IFB #17-413
INTERSTATE DRIVE MULTI-USE TRAIL PROJECT, TAP-7304(608)
ADDENDUM 1

Addendum1 issued November 3, 2017

DWG. No. RA-4115-41-7A

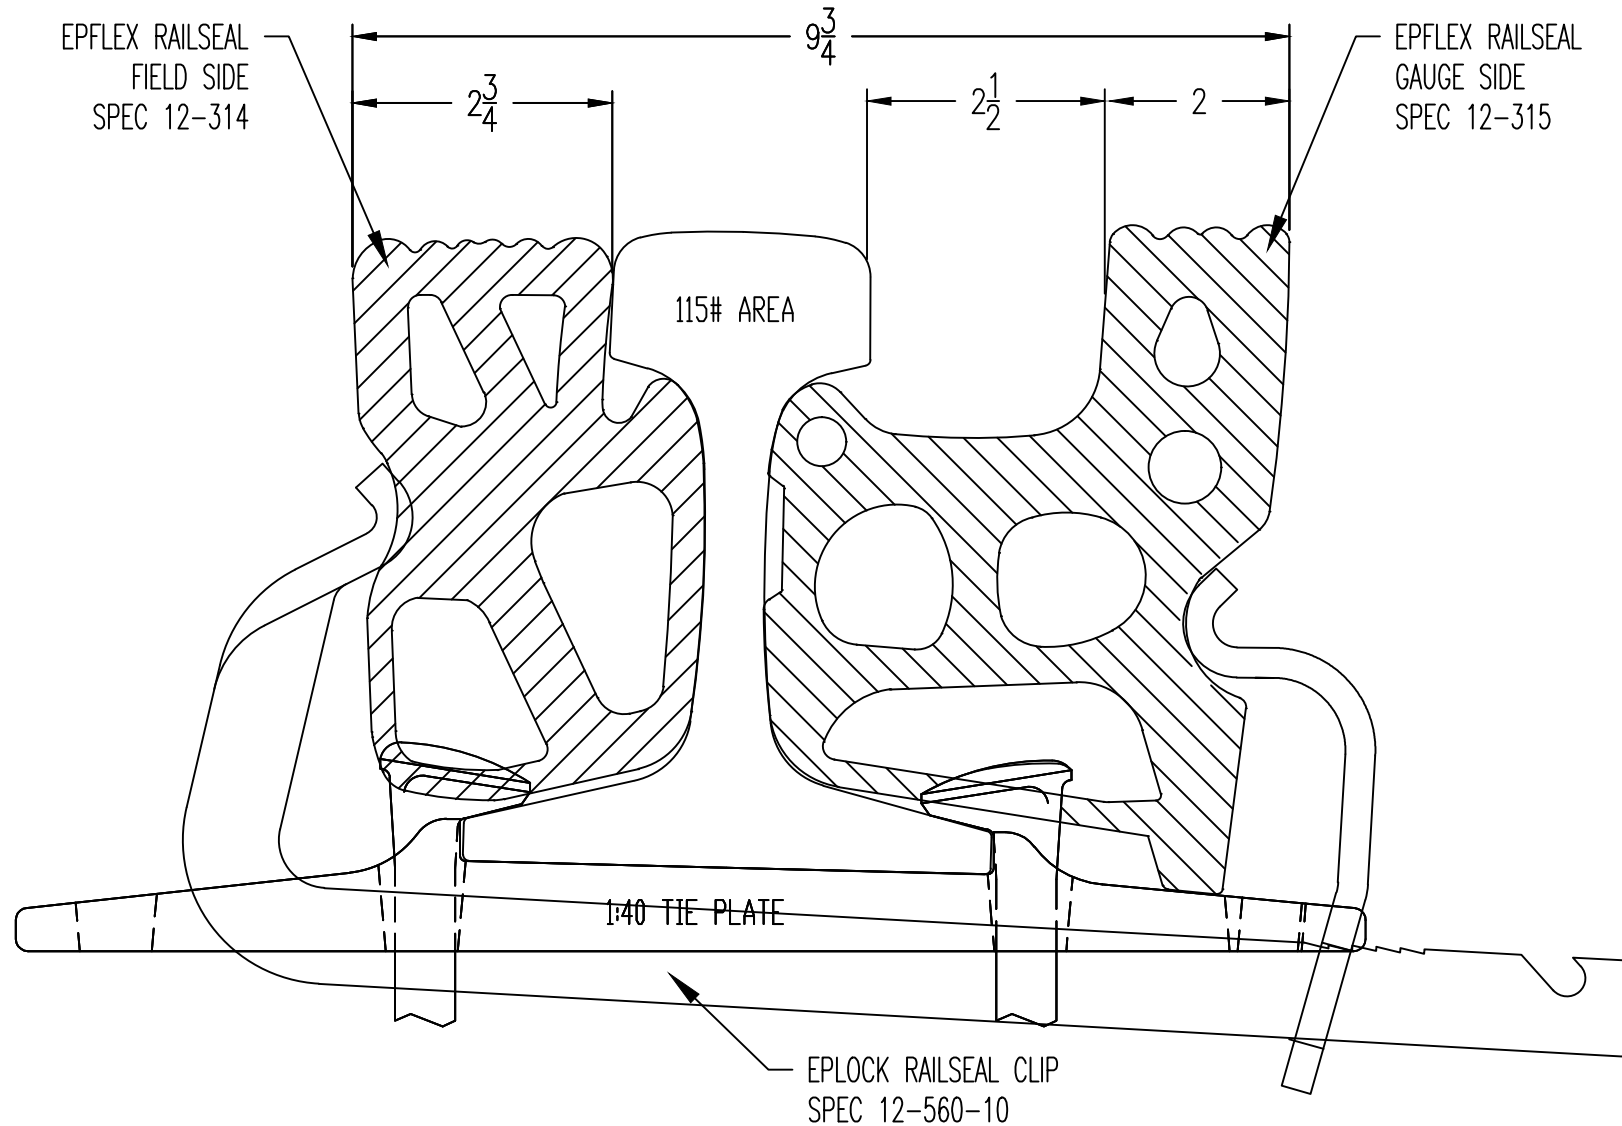
The representative for Polycorp provided a detail of their rubber gasket railway for the 115# rail. Also, of note, there is a joint bar connecting two rail sections within the foot print of the sidewalk. Therefore, the rubber gasket will have to be cut by the Contractor using the specifications as attached.

Gauge Side

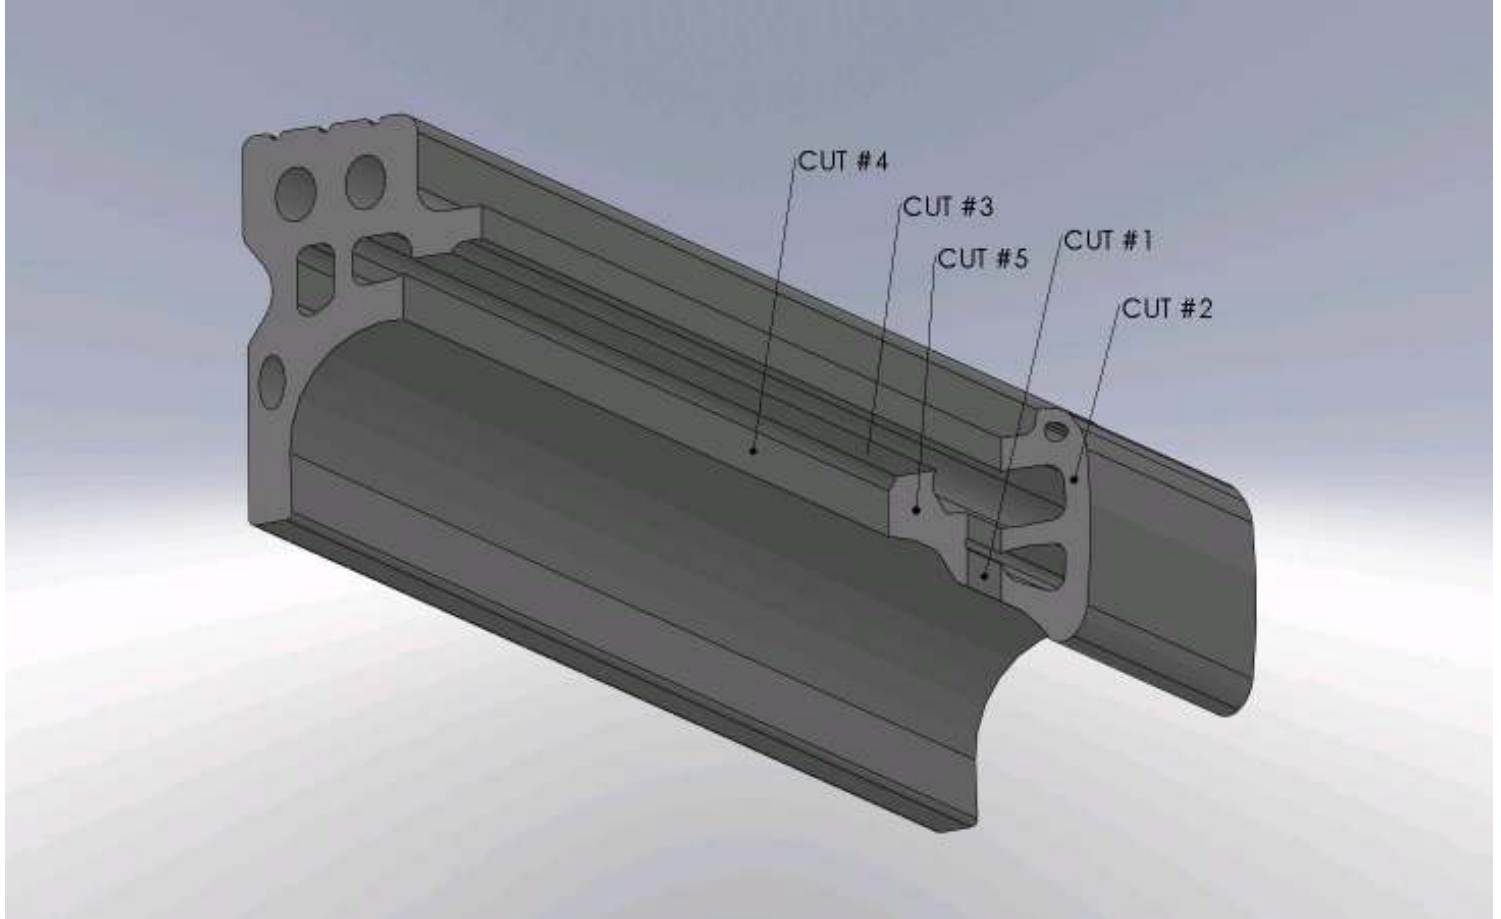
Cuts 1 and 2 are to fit around the actual joint bar. The remaining cuts are to accommodate the nuts. Field measure the joint bars and bolts, and cut railseal to fit. As an alternative, individual notches could be cut for each nut. The bolt heads will require at most a small cut out.

Field Side

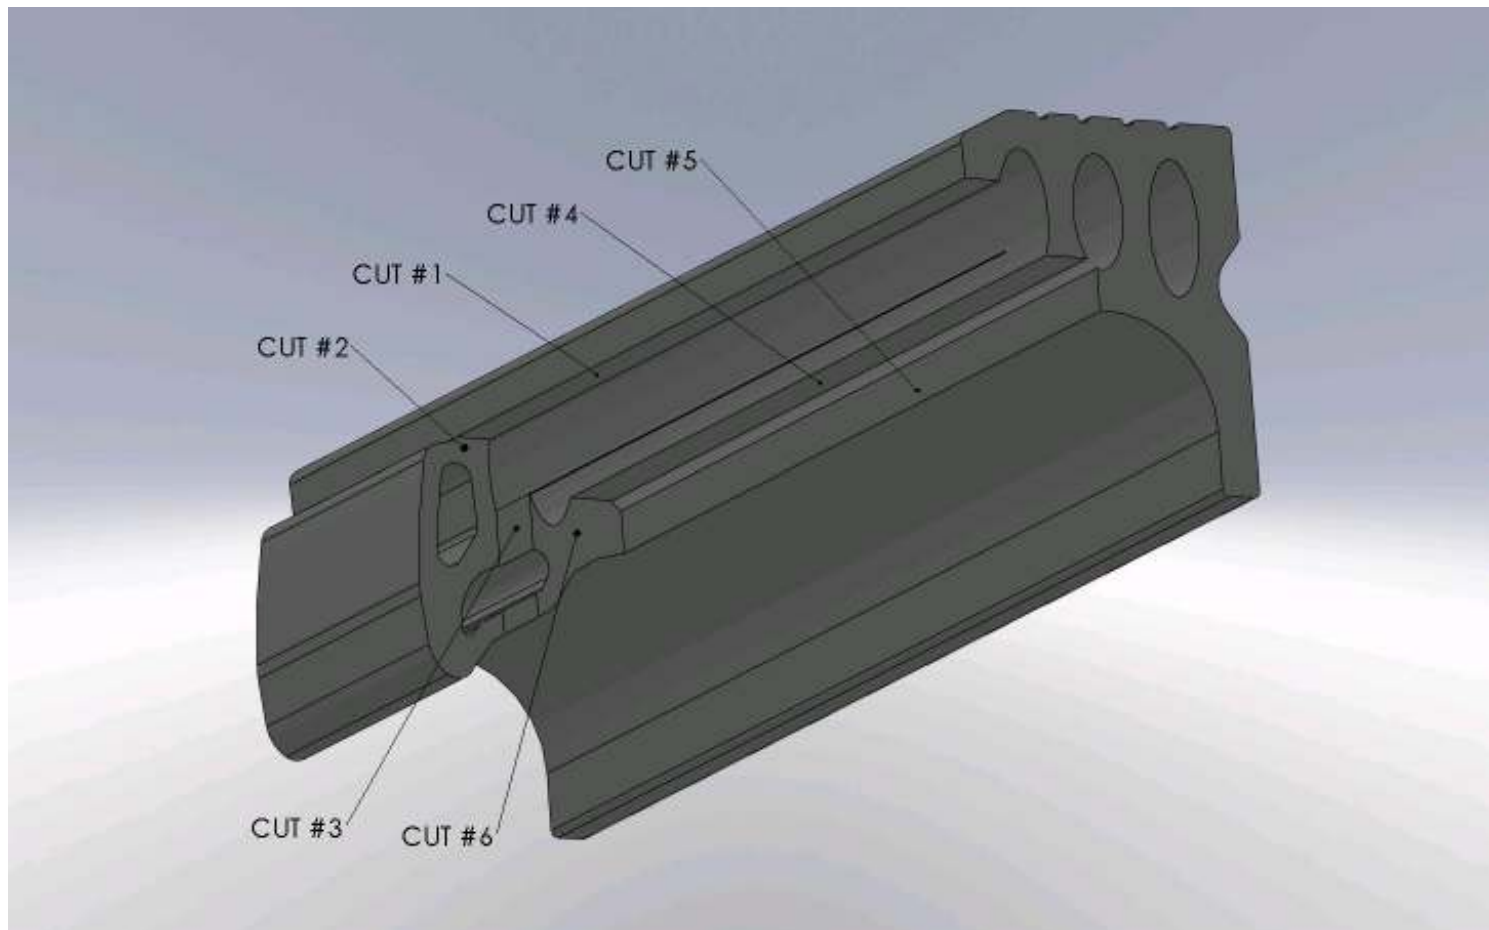
Cuts 1, 2 and 3 are to fit around the actual joint bar. The remaining cuts are to accommodate the bolts. Field measure the joint bars and bolts, and cut railseal to fit. As an alternative, individual notches could be cut for each bolt head and nut.
